DEPARTMENT OF THE INTERIOR Mail - Environmental Water Caucus Comments on Shasta DEIS

ENVIRONMENTAL WATER CAUCUS RESPONSE LETTER TO
THE U.S. BUREAU OF RECLAMATION FOR THE SHASTA
LAKE WATER RESOURCES INVESTIGATION DEIS
SEPTEMBER 30, 2013

Subject: Comments on Draft Environmental Impact Statement dated June 2013

Figure 1. Source: US Bureau of Reclamation delivery data from the Central Valley Projects Operations Office online.

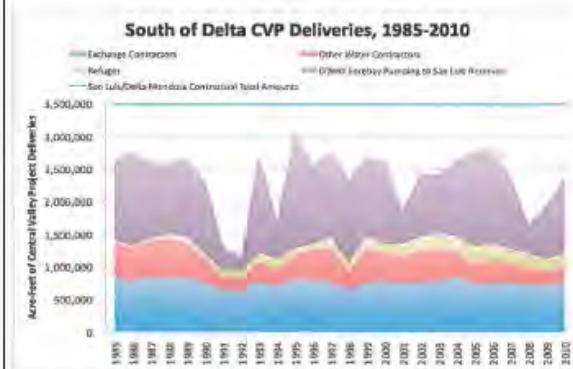
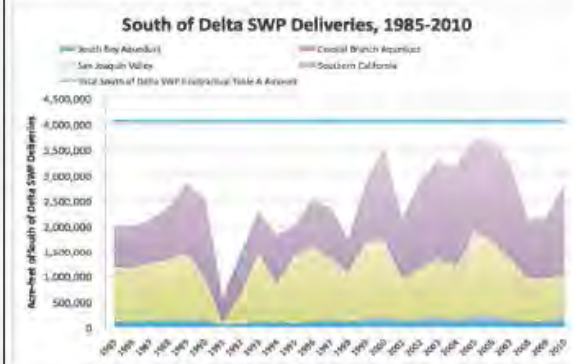
EWC-25	
EWC-26	<p>Figures 1 and 2 below document the quandary of chronic shortfalls in deliveries to contractors of California's state and federal water systems. In 1960, the California Department of Water Resources (DWR) announced its approach to the Delta and to providing additional imported water supplies. The Department announced then that the Delta had about an average of 3 million acre-feet annually available for export to state and federal water contractors of the San Joaquin Valley and southern California. This amount would hold until about 1981, according to DWR, by which it planned to build reservoirs on North Coast rivers like the Mad, the Van Duzen, the Eel, and the Trinity. About 5 million acre-feet was thought to come from those reservoirs for export to the Sacramento Valley to increase flows to the "Delta pool." From that "pool," surplus water could, DWR argued, be safely exported from the Delta.</p> <p>Only the Trinity River Division of the CVP was completed. The other streams are now designated as wild and scenic and development of their flows for diversion has long been off the table.</p> <p>Figure 1 below summarizes CVP south of Delta deliveries between 1985 and 2010. This chart also presents a line at the top that represents 3,488,246 acre-feet, the total amount of "annual entitlements" reported in the Bureau's Draft Hydrology, Hydraulics, and Water Management Technical Report.¹ There is a substantial gap between the amounts that</p>

represent deliveries to contractors during this period and the original "annual entitlements" claimed by the parties to the CVP water service contracts. The average difference between contract "entitlements" and actual deliveries south of the Delta exceeds 1.119 million acre-feet per year.

Figure 2 summarizes State Water Project south of Delta deliveries between 1985 and 2010. This chart, similar to Figure 1, presents a line at the top that represents 4,056,205 acre-feet, the total Table A amounts in State Water Project contracts for deliveries south of the Delta. Here too there is a substantial gap between the amounts that represent deliveries to contractors during this period and the original "Table A" amounts claimed

EWC-26: Please refer to Master Comment Response WSR-1, "Water Supply Demands, Supplies, and Project Benefits."

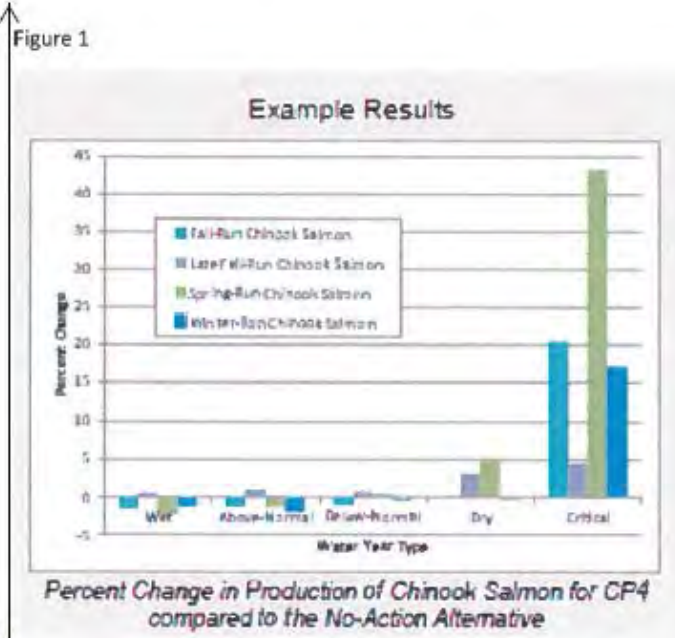
FOTR2-2 The graphic in Figure 1 claims that the 18.5' dam raise will improve production of Chinook salmon in dry and critically dry years. (Presumably the direct mechanism of such improvement would be deeper water keeping cold water colder, and more cold water for release in late summer and early fall.) The only way that additional storage volume, at the top of the dam, can improve conditions for salmon in dry and critically dry years is for the additional storage to fill, or partially fill, in the year prior to the dry or critically dry year.

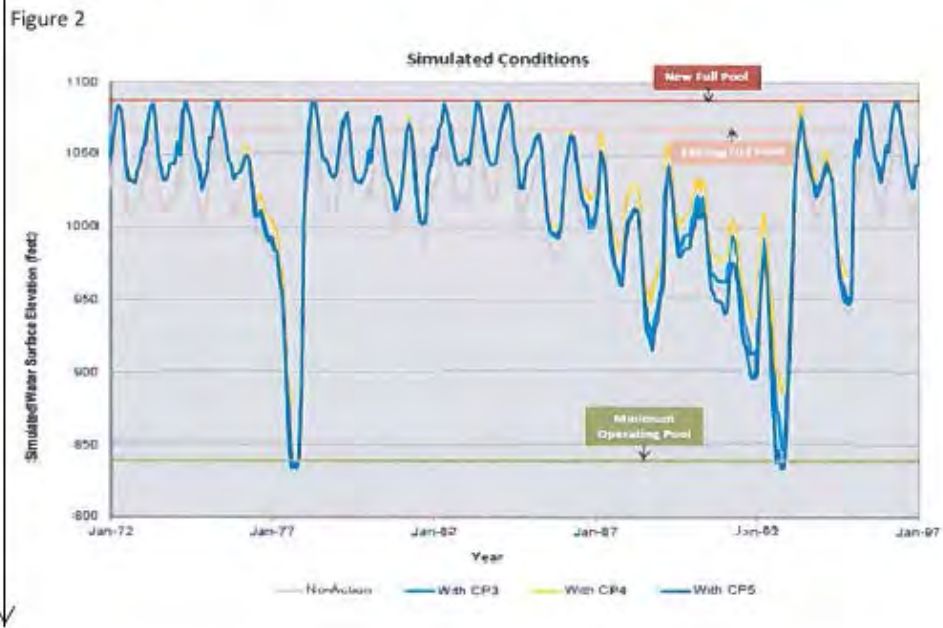
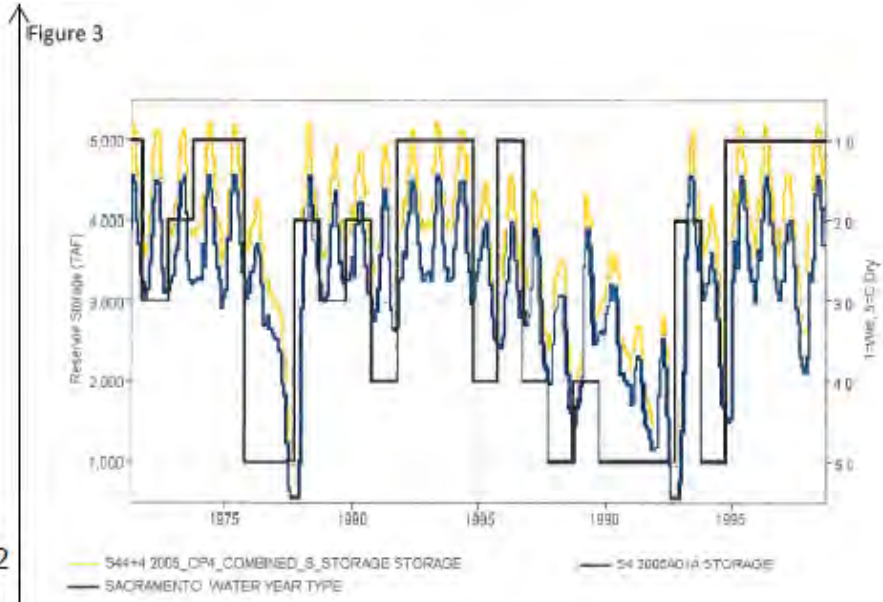
Figure 2 shows water surface elevation at Shasta for various operating scenarios, including CP4, the alternative that claims the greatest salmon benefit. Figure 3 shows the no action alternative, CP4 and water year type.

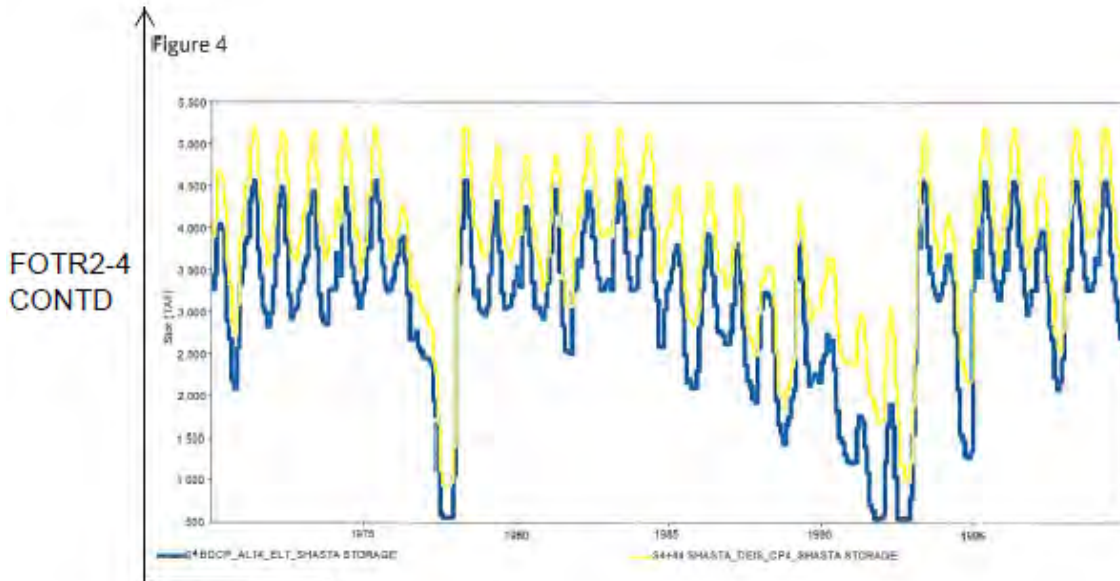
In addition to being probably impossible under current constraints, Figure 4 shows that operating Shasta at a higher level is contrary with the preferred BDCP alternative.

FOTR2-4: It appears that the referenced “Figure 4,” which was provided as part of the commenter's letter, shows simulated storage levels in Shasta Reservoir under the CEQA preferred BDCP alternative (blue) and under the SLWRI DEIS action alternative CP4 (yellow). It is unclear if the simulated storage levels in Shasta Reservoir under the BDCP alternative were based on outputs from modeling related to the BDCP DEIS. It is also unclear whether these storage levels are intended to represent existing or future conditions for each project.
